Planning Commission Minutes
March 14, 2024

20. (SPUD-1606) Application by The Alley OKC, LLC to rezone 1625 North Marion Avenue from R-1 Single-Family Residential and Gatewood Urban Conservation Overlay Districts to SPUD-1606 Simplified Planned Unit Development and Gatewood Urban Conservation Overlay Districts. Ward 6.

STAFF REPORT
The City of Oklahoma City
Planning Commission
March 14, 2024

SPUD-1606
UTILITY PLAN
EXHIBIT "D"

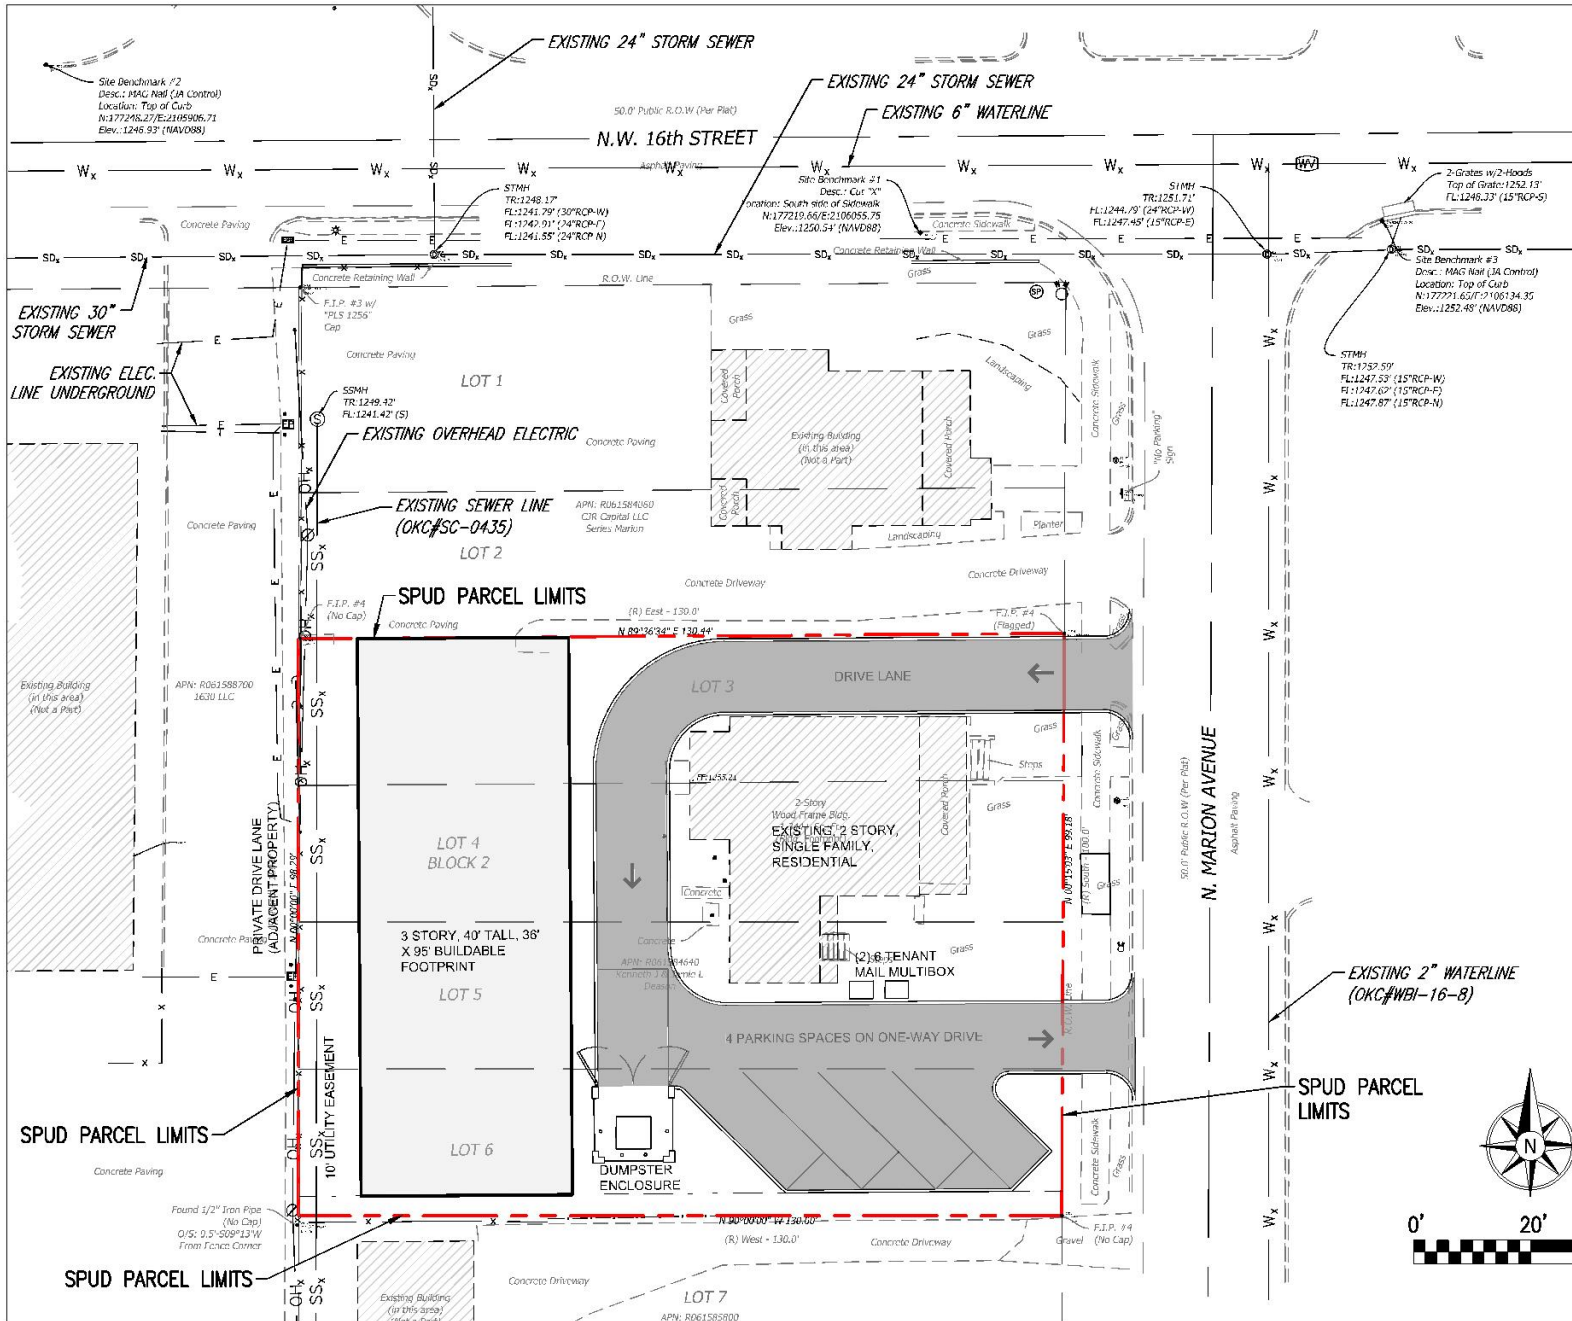
- 1. Airports**
- 2. Central Oklahoma Transportation and Parking Authority (COTPA)**
- 3. Fire:** Objection; minimum fire access road is 14 feet wide with a 10-foot radius. Fire lane at truck area needs to be a minimum of 20 feet wide.
- 4. Information Technology/Geographic Support**
- 5. Parks and Recreation**
- 6. Police**

Will require new tap into existing 8-inch wastewater main.

Can use existing services or installation of new water meter along N. Marion Avenue in the right-of-way.

The subject site currently has one improved drive along North Marion Avenue. The SPUD regulations call for no more than two drives along North Marion Avenue. The conceptual plan shows the two drives from N Marion Avenue looping around the existing home and creating a one-way drive lane with access to the dumpster enclosure and four parking spaces on the west side of the property.
